Technical change to RSM-16 and RS16IO

PCN-number: 20251028

Sample photo of the old versions of modules
9447100000 (left) or 9447100000 (right)

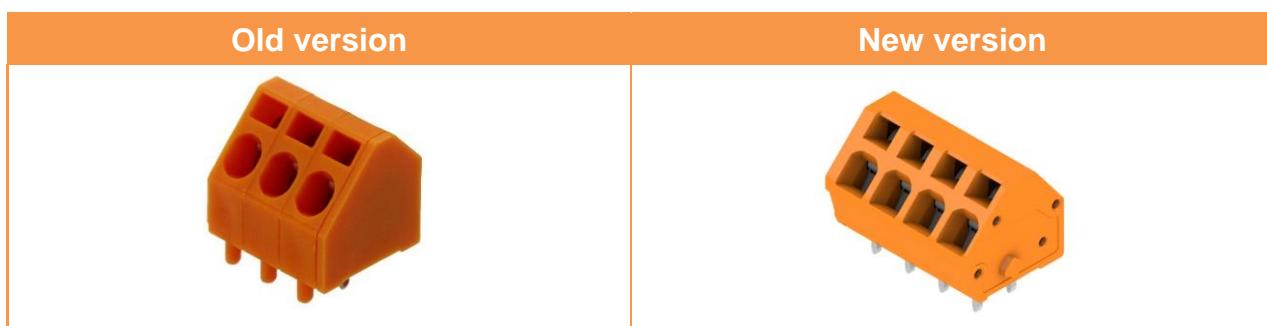
Based on continuous improvement, the LMZF 5.08 connector range will be replaced by the LMZF 5.00 connectors. The PCB of this module has also been replaced so that the LMZF 5.00 connectors fit properly on the module frame. The replacement will affect all articles listed in section 5.
Also, the LEDs of module 9447100000 RSM-16 C 1CO Z will be replaced by other LEDs with higher temperature tolerance.

Obsolescence LMZF 5.08 connector range.

Regarding the replacement of LEDs, the reasoning is to allow the raise of maximum temperature that the module can withstand from 40°C to 50°C.
